UNITED STATES PATENT AND TRADEMARK OFFICE

Office Action Summary

10/089,727

DETAILED ACTION

FIG. 7.

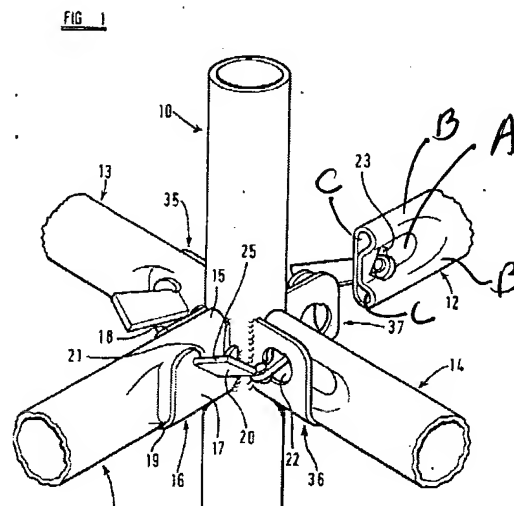
2. Claims 7-8 are rejected under 35 U.S.C. 102(b) as being anticipated by Barton (UK Patent GB No. 2,045,886).

Barton teaches a longitudinal tube (12) (see Fig.1 bellow) comprising: opposed end portions including a flat land (A) at a central location of each end of the tube, wherein said flat land (A) could be formed by a method of either crushing, compressing or pinching to abut together, said flat land is capable to receive a fixing element, and the tube further including a longitudinally extending non-crushed region (B) being formed laterally either side of the crushed region to define ribs/sub-tubes (C) on lateral sides of the tube.
